INDESIT company

Model type:
WAX80EX

Commercial code:
F028415

1230110 Exploded views

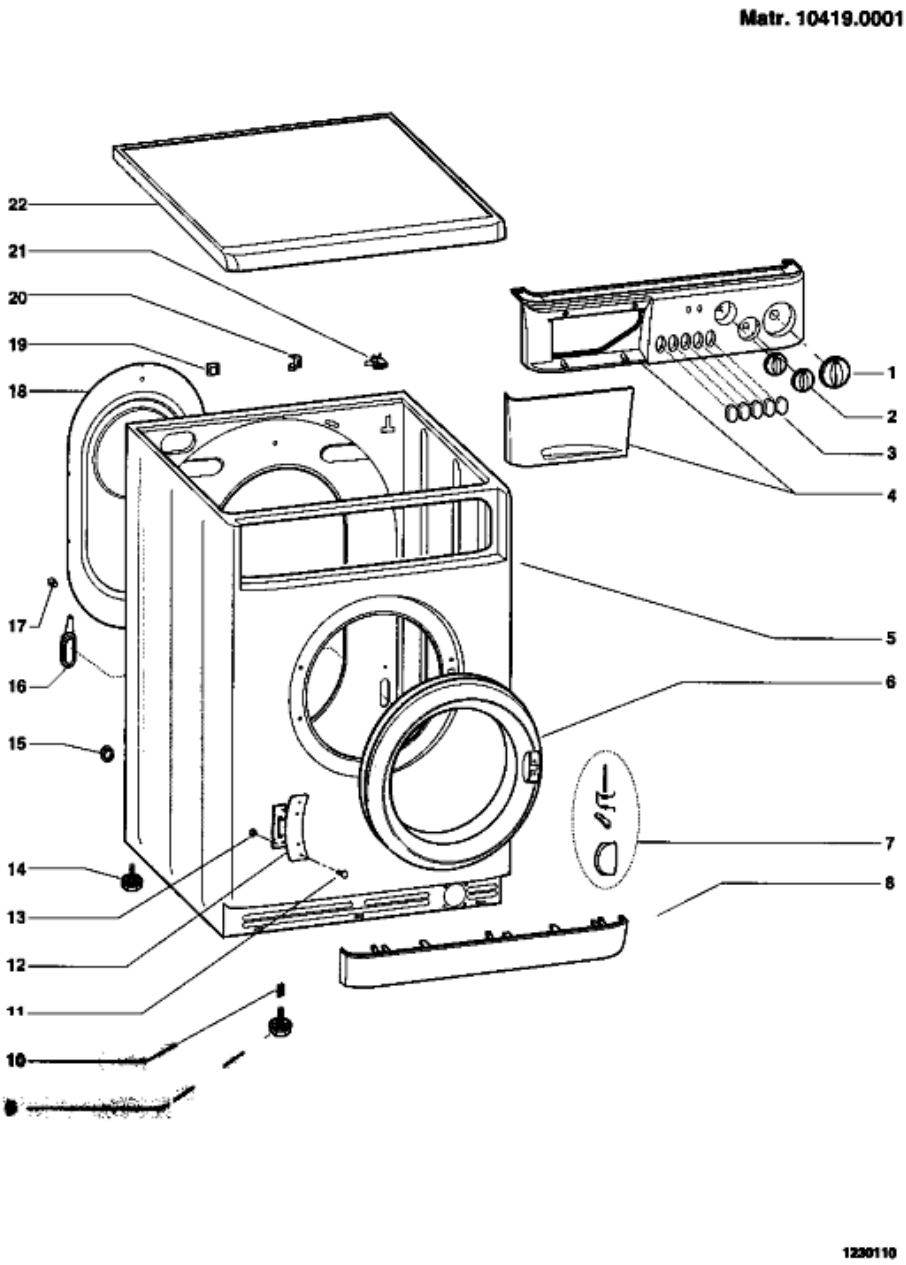
n1040308: Reduction of cabinet depth on 6kg EVOI washing machines produced at Brembate

From serial no. 30915.0001, all 6 kg washing machines affected by this note have been modified due to the reduction in cabinet depth.
The modified models have a new industrial code.
The parts affected by the modification are: cabinet, packing kit, top, product dispenser lid (including solenoid valve) and cabinet base plate (for USA models).
Regarding the packing kit, top, product dispenser lid and cabinet base plate, the Replacements Warehouse will continue to manage premodification and new parts.
The premodification cabinets will be managed while stocks last, after which, in case of cabinet replacement the new cabinet, top, product dispenser and cabinet base plate (USA models only) must be used, referring to the spare parts list for the relevant model.
Given below is a list of models affected by the modification with relevant new and premodification parts:

WAX80EX (industrial codes: new 91284150001, premodification 91284150000);
Cabinet: premodification 091758, new 097793;
Packing kit: premodification 082598, new 098182;
Top: premodification 083290, new 097794;
Product dispenser lid: premodification 083995, new 097795.

1230210 Exploded views

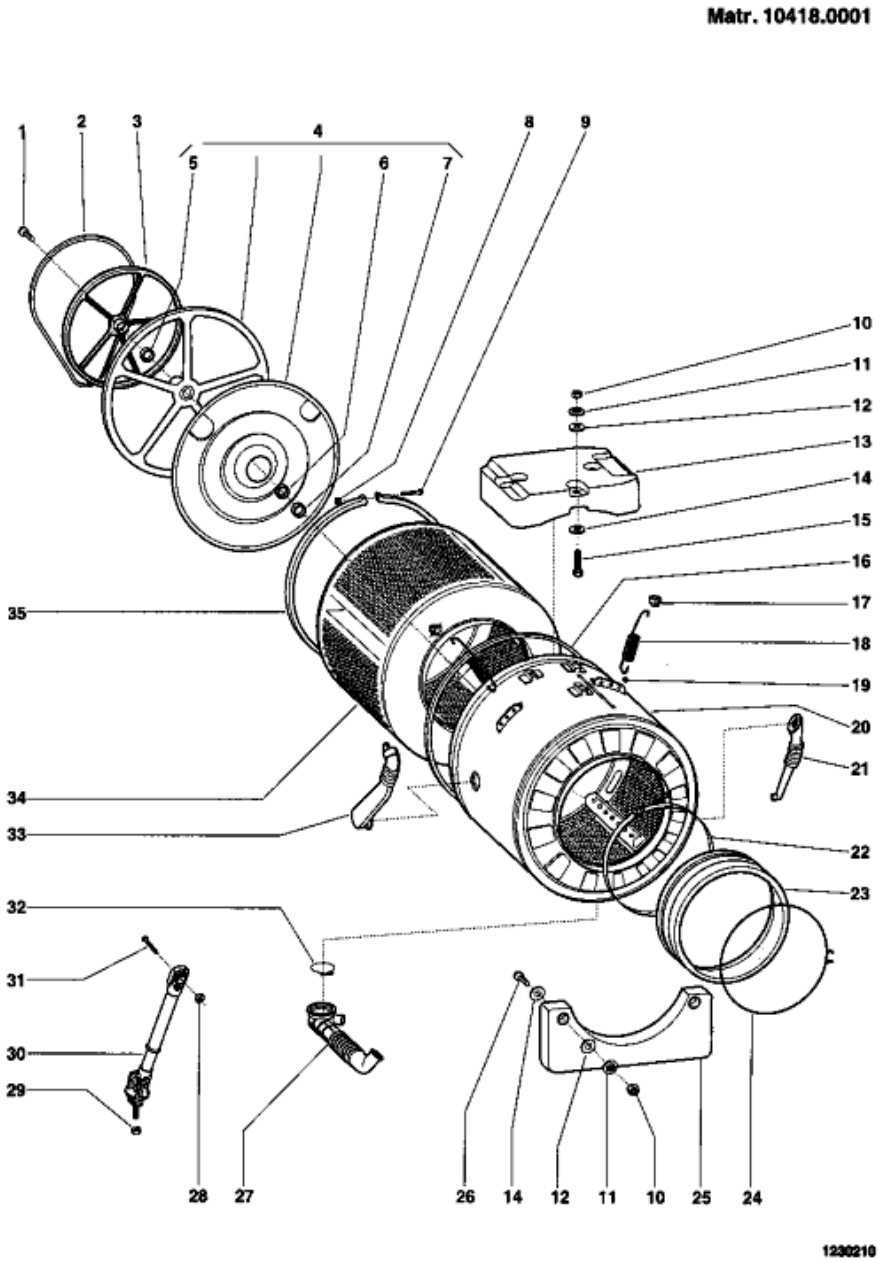
n1040298: Modification of s/steel tubs - dispensers - detergent loading tubes on Brembate

From serial number 30609.0001, all washing machines produced in the Brembate factory and affected by this note have been equipped with the new EVO2 detergent loading tube; the modification has also involved the tub (the detergent loading tube hole has been shifted forward) and dispenser.
The Sat codes of the new parts and the premodification items are given below:
DETERGENT LOADING TUBE (two instead of three):
-new 092161, premodification 064528;
-new 092273, premodification 080654;
-new 092161, premodification 074136;
DISPENSERS:
-for linear detergent drawer: new 092314, premodification 075351;
-for rotating detergent rotary drawer: new 092176, premodification 064529;
TUBS:
-new 095717, premodification 090589;
-new 095718, premodification 090934;
-new 095720, premodification 090206;

-new 095721, premodification 090321;
-new 095722, premodification 091050;
-new 095723, premodification 090588;
-new 095724, premodification 088402.
Regarding the detergent loading tubes and dispensers, the new and premodification parts will continue to be used.
The premodification tubs will be managed until stocks run out, after which, when a tub needs replacing on appliances prior to serial number 30609.0001, the new tub plus the new detergent loading tube and new dispenser must be used (refer to the replacement parts list for the relevant model).

n1040310: Dampers with 8 mm fixing hole on machines produced in the Brembate factory.

From serial no. 31120.0001, dampers have been fixed to the bowl with an 8 mm diameter screw (code 098724) in place of the 10 mm screw (code 030446) and relevant locking nut code 098723 in place of code 030680, on front-load washing machines produced in the Brembate factory.
The spare part codes of the new dampers with 8 mm fixing hole are:
098721 (120N);
098722 (100N);
Premodification items with 10 mm hole spare part codes 093648 (120N) and 093649 (100N) will continue to be available.
The diameter of the damper fixing holes has been reduced on the motor/damper brackets (088403-090586) and s/steel bowls (095723-095724-095718-095717-095720-095721-095722) maintaining the same spare part code; the holes must be widened if necessary.

1230310 Exploded views

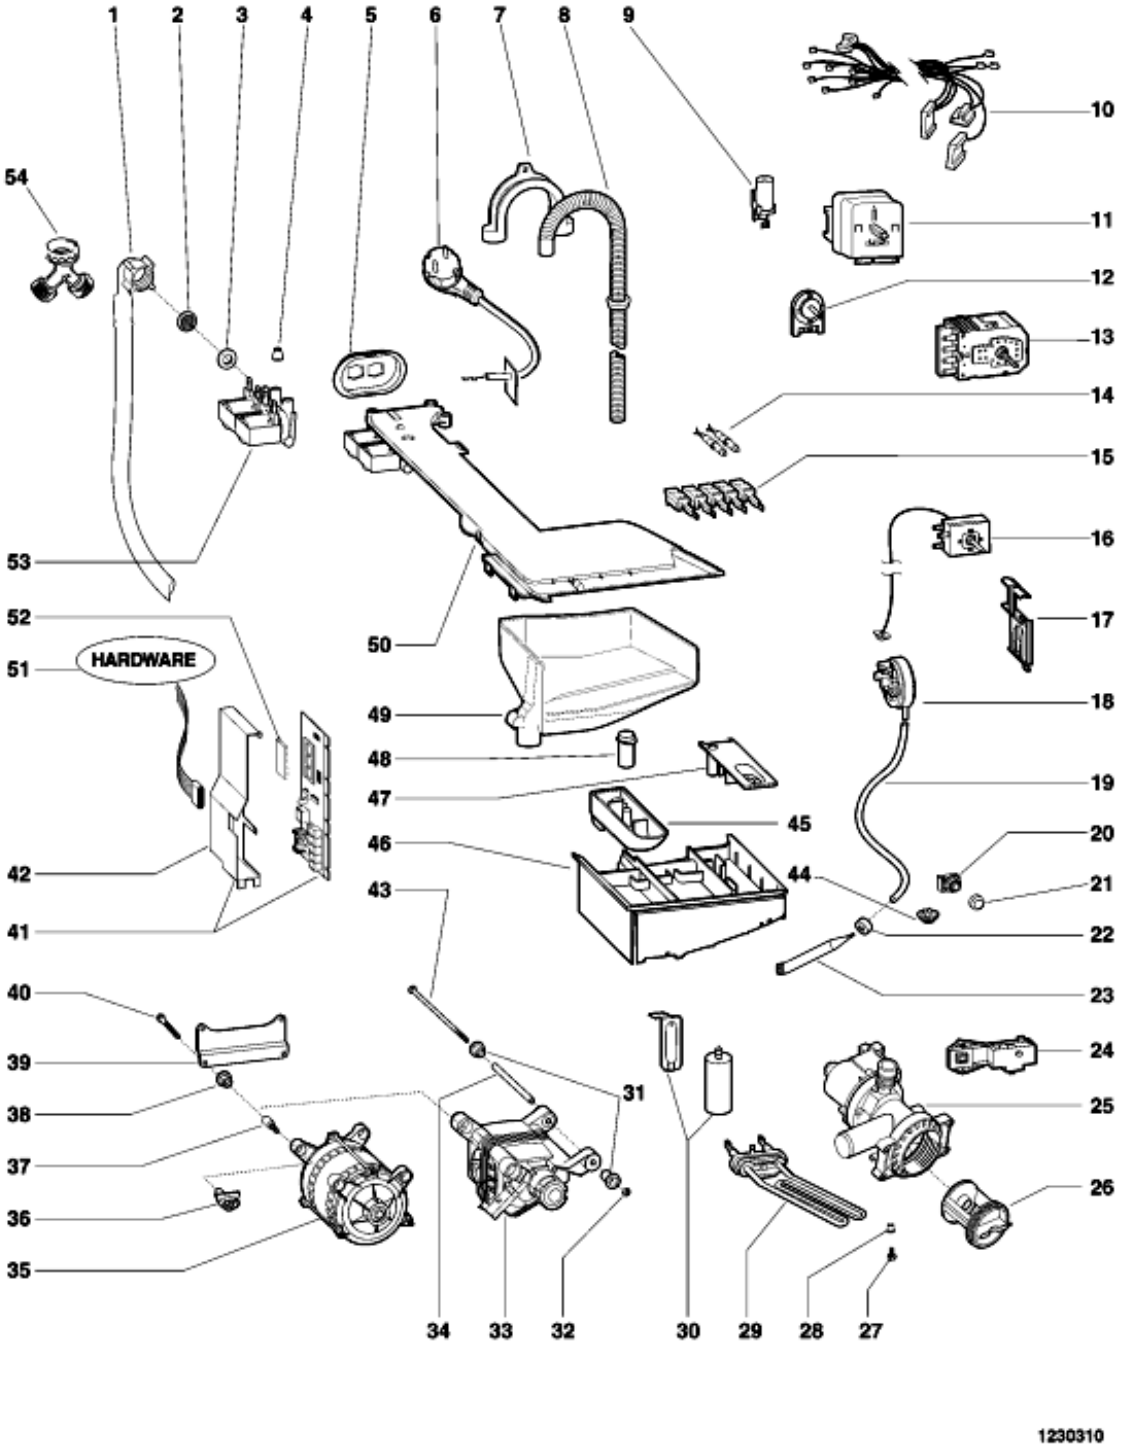
n1040277: Modification of pressure switch protection and tube

From serial no. 21104.0001, all washing machine models produced in the Brembate factory and relevant to this note have been equipped with a new pressure switch tube 041785 replacing 051552, a new pressure switch tube protection 019755 replacing 078221 and two plastic clamps replacing terminals 051541.
premodification parts will be managed until stocks run out and are interchangeable with the new ones only if used altogether.
